CONDITION SURVEY REPORT  
FOR  
CONSULTANCY SERVICES FOR COLLEGE BUILDINGS AND INFRASTRUCTURE  
TO BE REHABILITATED (REVIEW BILL OF QUANTITIES, ASSOCIATED DESIGN,  
DRAWINGS AND SUPERVISION OF REHABILITATION WORKS)

**PROPOSED REHABILITATION OF ESTATE AND PMU BUILDING.**

**LOT 2.1 - ESTATE AND PMU BUILDING.**

ROOF PLAN

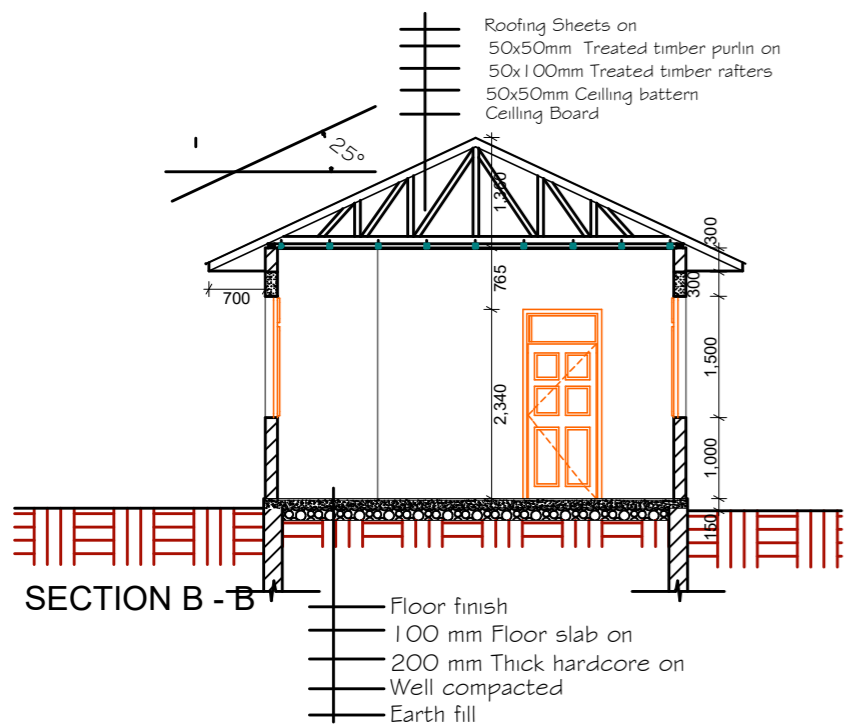
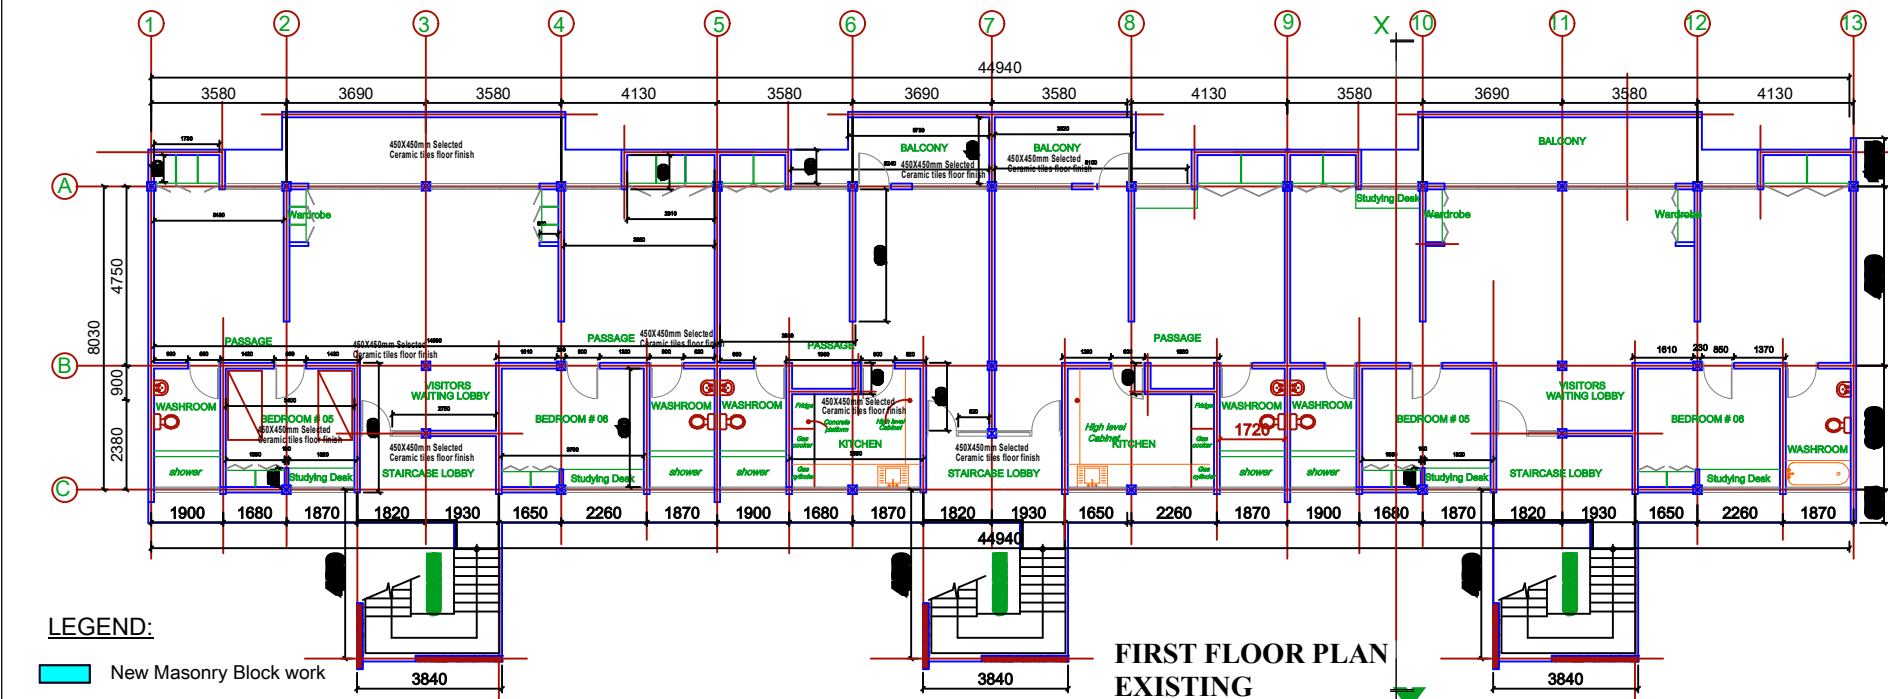
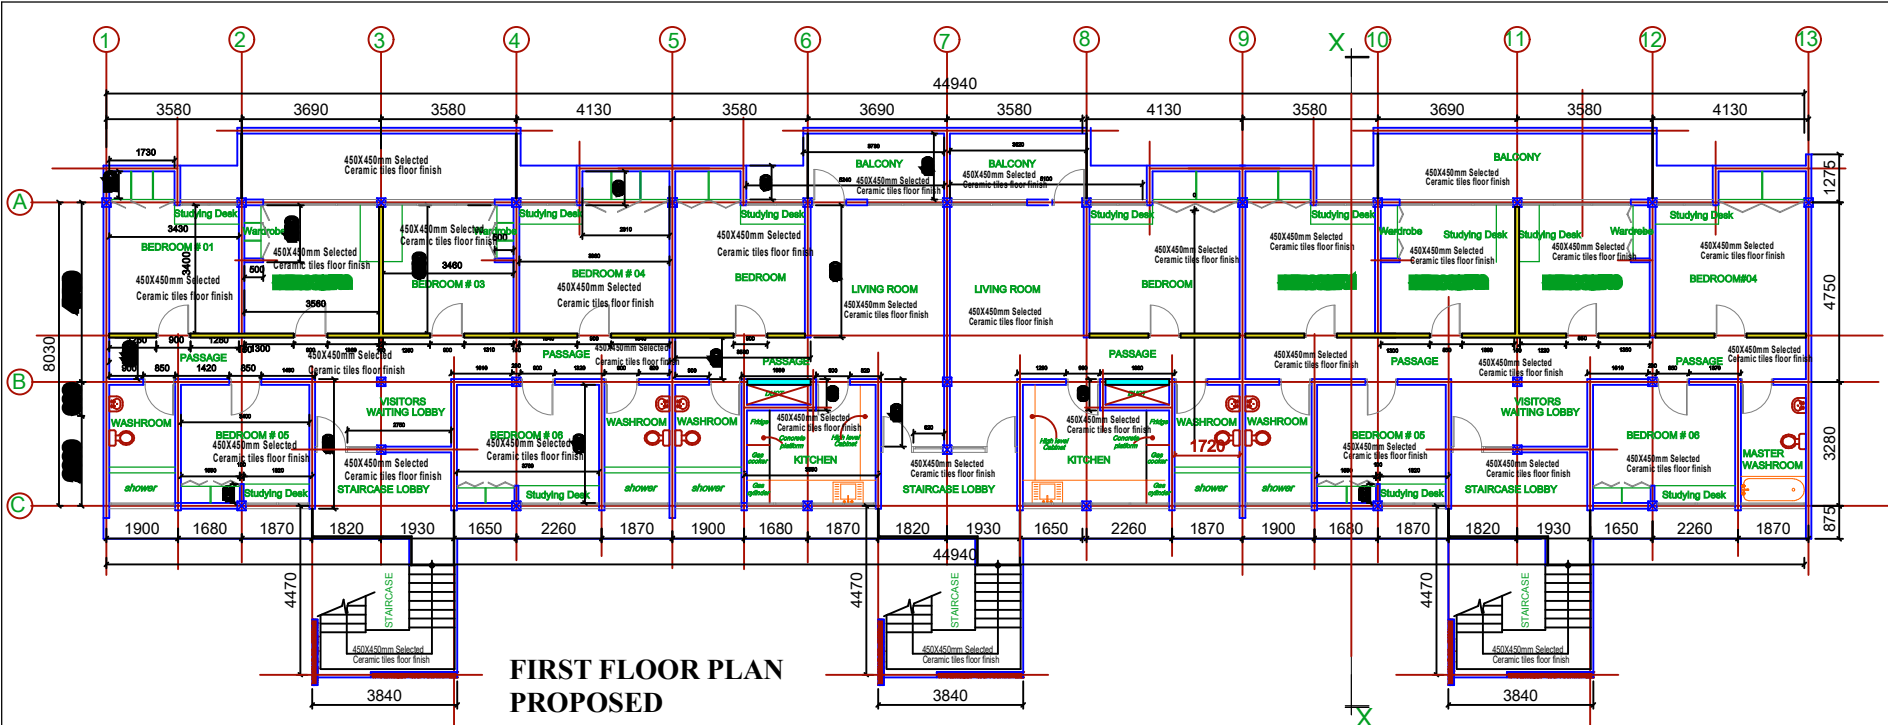
1.1	<b>WORKS TO ROOFS</b> Remove existing roofing sheets to replace with 28Gauge Resin colour coated IT5 Aluminium sheets the new one.  <b>Quantity=100 sq.m</b>	For this building, only red colored roof sheets to be removed. The rest to remain. As Consultants, we recommend all roofing sheets to be IT 5 with 26 Gauge since it is more durable than 28 Gauge. <b>Quantity = As per drawing</b>

- 1: Roofing sheets to be removed and replaced with 28G sheets.
- 2: Roofing sheets to be retained.

EXISTING WINDOWS

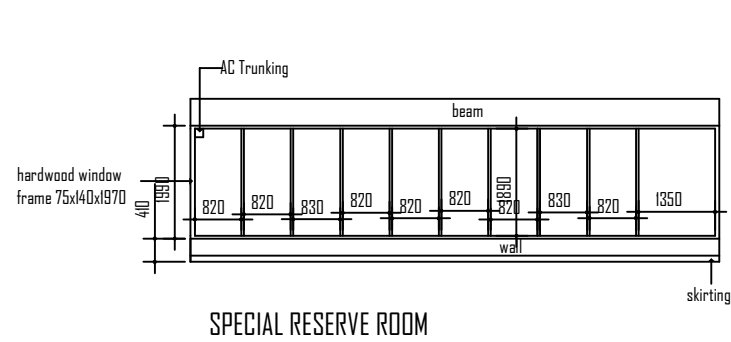
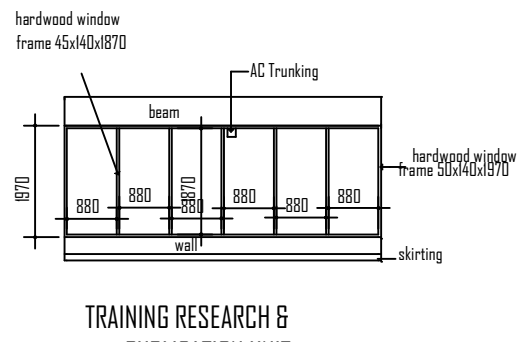
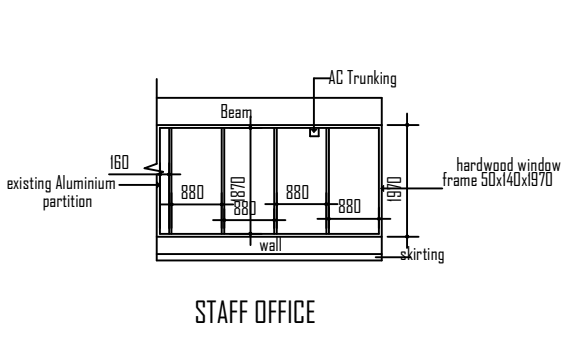
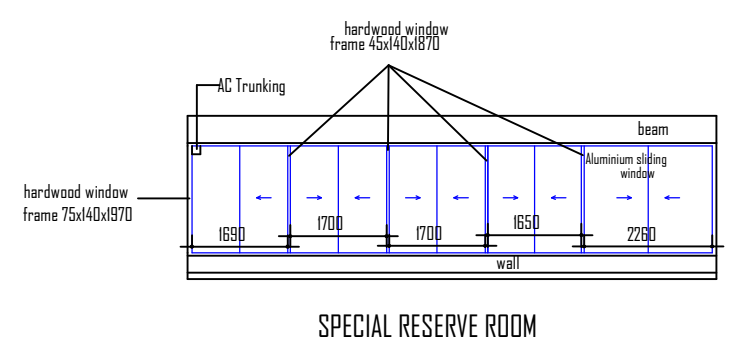
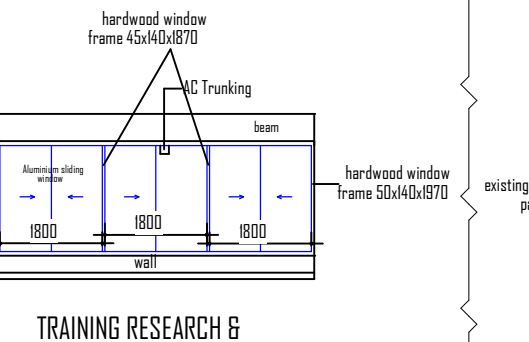
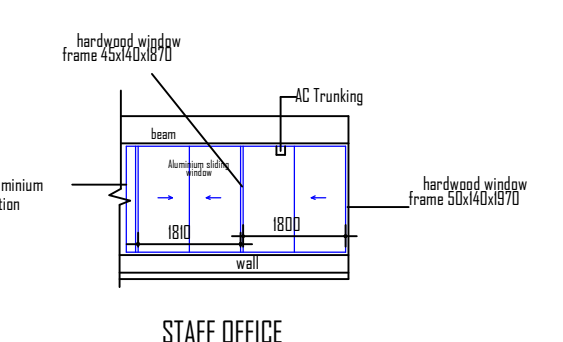
4.5	<p><b>ALUMINIUM WORKS</b> Carefully, dismantle; remove the louvers glasses windows and prepare the surface left behind including make good work disturbed. Supply and fix Aluminum (Sliding) windows. <b>Quantity= 6 Nos.</b></p>	<p>Louvered glass windows will be removed and replaced with Aluminium</p> <p><b>Quantity= As per drawing</b></p>

EXISTING  
GROUND FLOOR PLAN

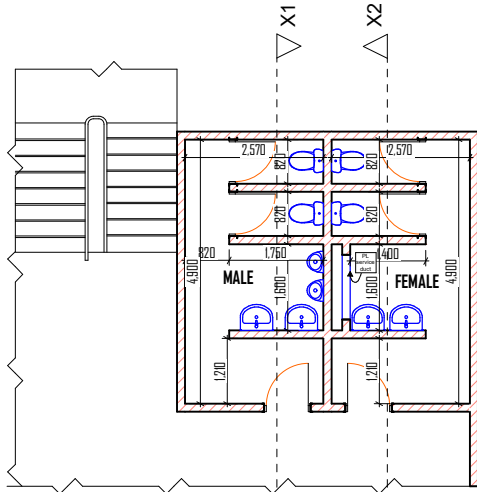
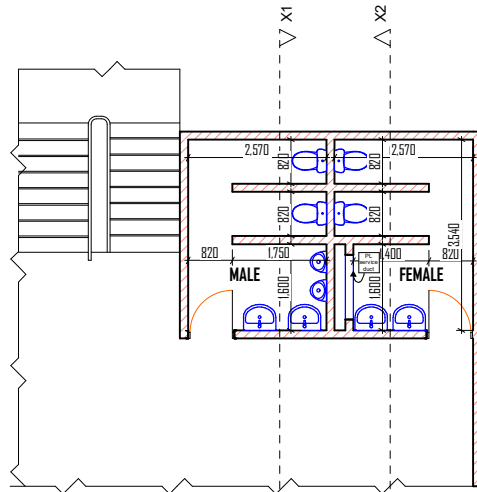
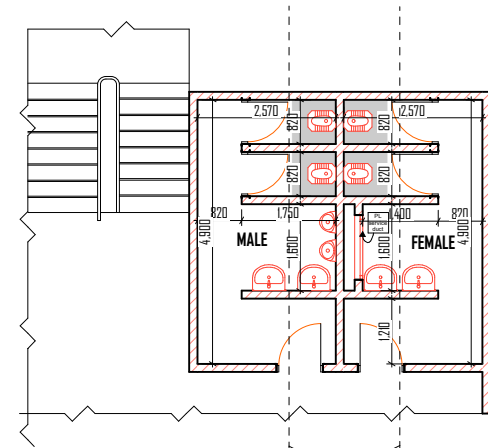
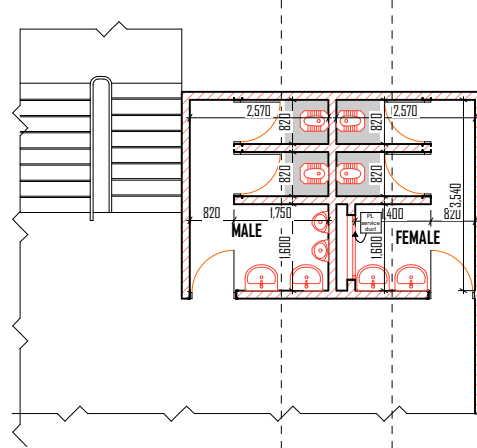
4.2	<p><b>MASONRY WORKS</b> <b>Toilet Floor:</b> Remove wall and floor tiles in order to allow construction with masonry blocks to raise floor level by 300mm high and increasing the height of partition walls for enabling to change Western WC type to Eastern WC type. <b>Quantity= 5.6 Sq.m.</b></p>	<p>Floor level will be raised and partition walls height will be increased.</p> <p><b>Quantity= As per drawing</b></p>

PROPOSED ROOF PLAN

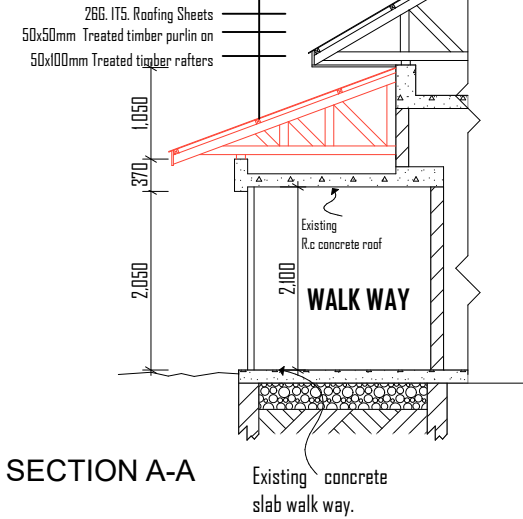
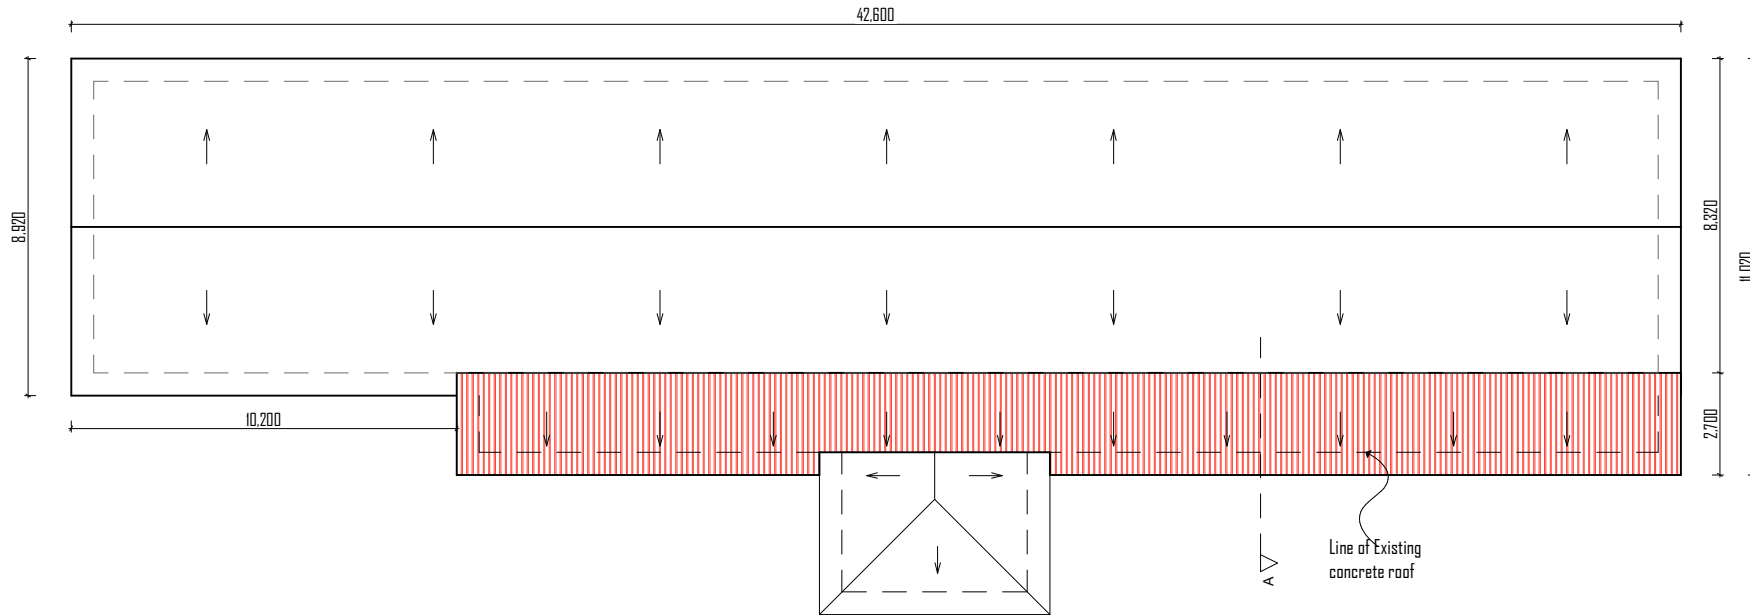
<b>VOLUME 2.7 - SCIENCE BLOCK</b>			
<b>S.No.</b>	<b>SCHEDULE OF REHABILITATION WORKS AS PER B.O.Q</b>	<b>CONSULTANT'S REVIEW AFTER A CONDITION SURVEY</b>	<b>PHOTOGRAPHS</b>
7.1	<b>ROOFING OF THE CONCRETE FLAT ROOF</b> Supply and fix roofing materials for roofing leaking concrete flat roof including painting materials on roof.  <b>Quantity=20 NR</b>	IT 5 roofing materials with 26 Gauge will be fixed  <b>Quantity = As per drawing</b>	
7.2	<b>PAINTING</b> Wire-brush the surface to remove existing paint, prepare surface and apply weather guard paint to roof and walls.  <b>Quantity= 70 Sq. m</b>	Two finishing coats of Goldstar or equal approved will be applied  <b>Quantity = As per drawing</b>

- 1: New Roofing sheets to be replaced with 26G IT5 covered.
- 2: Existing Roofing sheets to be retained.

BLOCK B  
NEW ELEVATION

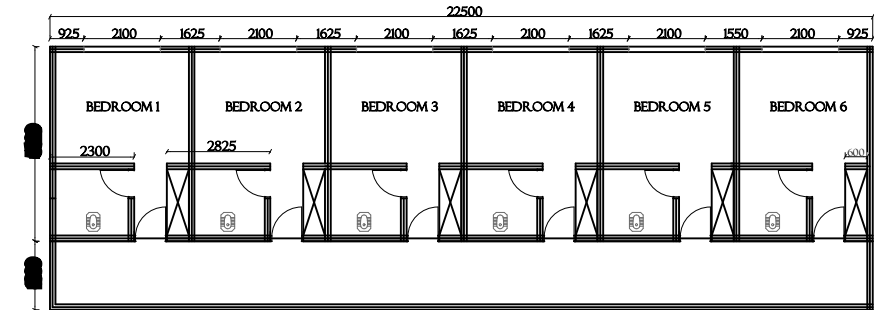
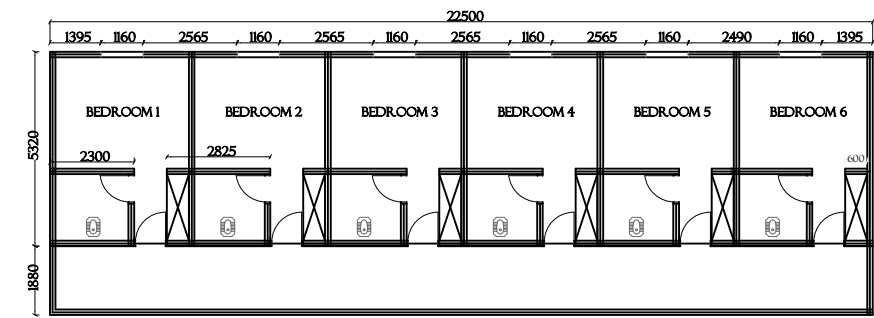
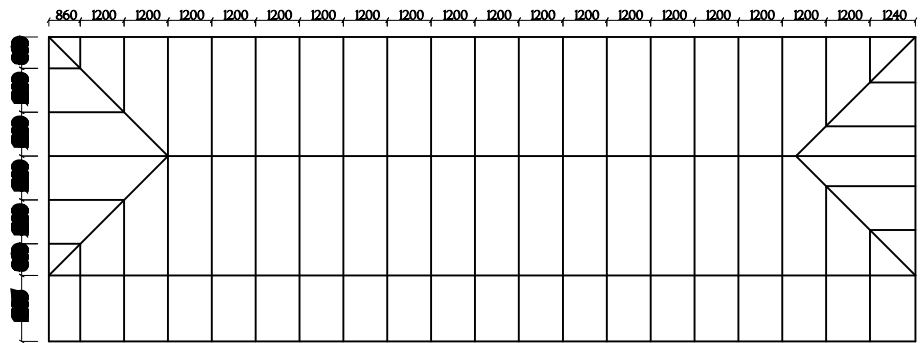
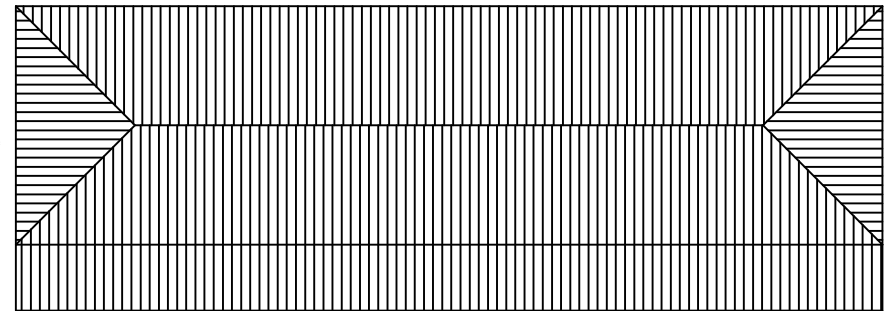
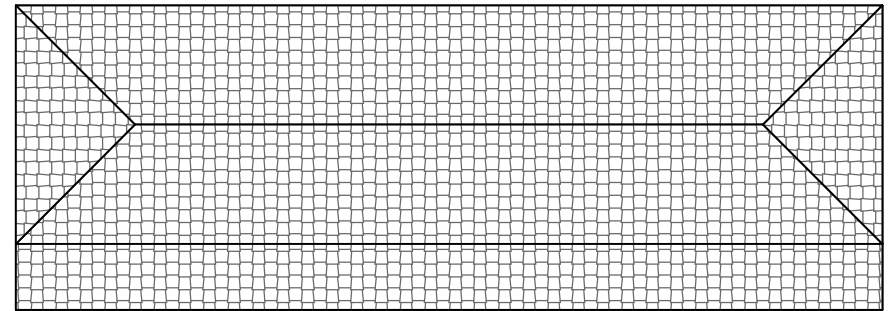
S.No.	SCHEDULE OF REHABILITATION WORKS AS PER B.O.Q	CONSULTANT'S REVIEW AFTER A CONDITION SURVEY	PHOTOGRAPHS
10.1	<b>DEMOLITION, ALTERATION AND BUILDERS' WORKS</b> Remove existing mangrove tiles together with underlying roof timber trusses and adjoining purlins and carefully assemble the same in locations within the hostels as directed by supervisor, <b>Quantity= 260 Sq.m.</b> Remove existing timber brandering complete with gypsum boards and cornice and carefully assemble the same in locations within the hostels as directed by supervisor <b>Quantity= 200 Sq.m.</b> Construct a 150mm thick wall on the stopping course of the existing wall to increase ceiling height including plastering and removal of debris resulting from works away from site. Fix 28gauge, IT5 precoated zinc Alum sheets complete with roofing ridges and associated fasteners (measured as plane surface) <b>Quantity= 90 Sq.m.</b>	Existing mangrove tiles will be removed. <b>Quantity= As per drawing</b>  <b>Quantity= As per drawing</b> 150mm thick wall on the stopping course of the existing wall to increase ceiling height will be constructed. <b>Quantity= As per drawing</b>

10.2	<b>ROOFING WORKS</b> Erect new timber trusses consisting of 50x150mm treated timber as of SAO HILL equivalent Tie beams, rafters and bracing chords fixed to 50x100mm wall plates and comprising of 50x50mm purlins and 25x250mm planed fascia boards as per drawing details, (measured in angle 45 degrees plane surface)  Fix 28gauge, IT5 precoated zinc Alum sheets complete with roofing ridges and associated fasteners (measured as plane surface) <b>Quantity= 320 Sq.m.</b>	IT 5 roofing sheets with 26 gauge will be fixed          <b>Quantity= As per drawing</b>
